Appl. No. 10/630,487
Amdt. dated Nov. 21, 2005
Reply to Office Action of July 21, 2005

Amendments to the Drawings:

REMARKS/ARGUMENTS

FIG. 4

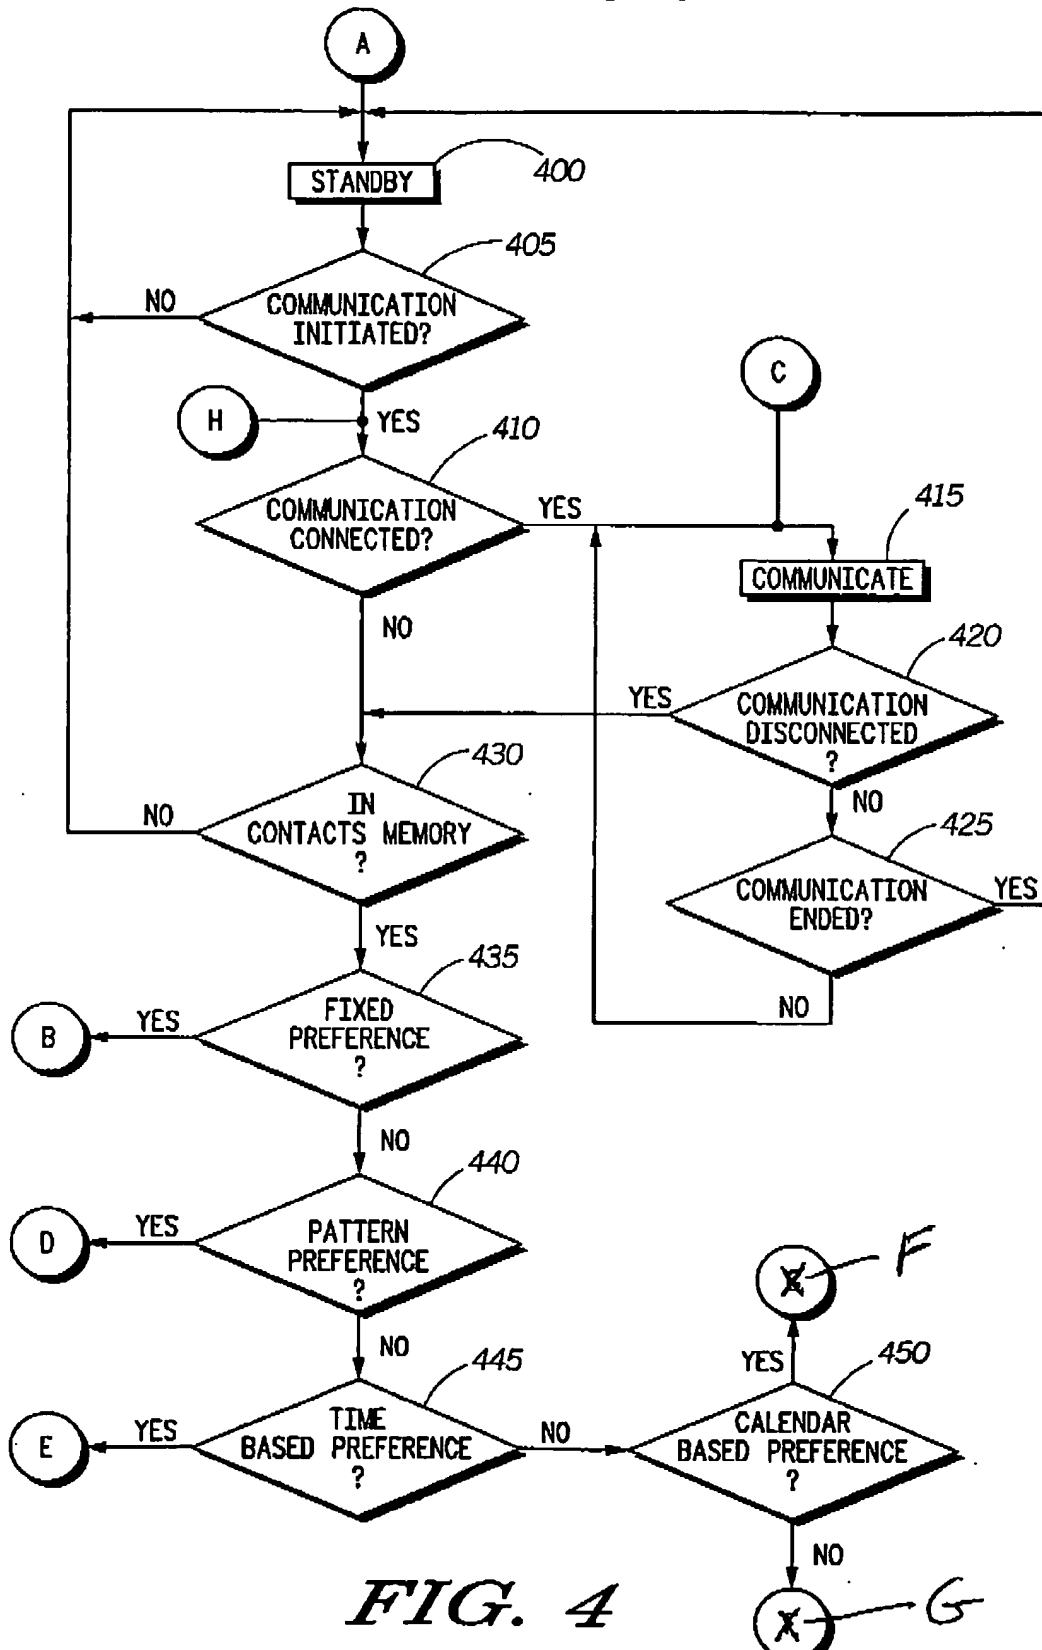
The attached sheet of drawings includes changes to FIG. 4. This sheet, which includes only FIG. 4, replaces the original sheet including FIG. 4. In FIG. 4, nodes "F" and "G" have been interchanged to more properly coincide with the recitations of the detailed description and FIGs. 8 and 9.
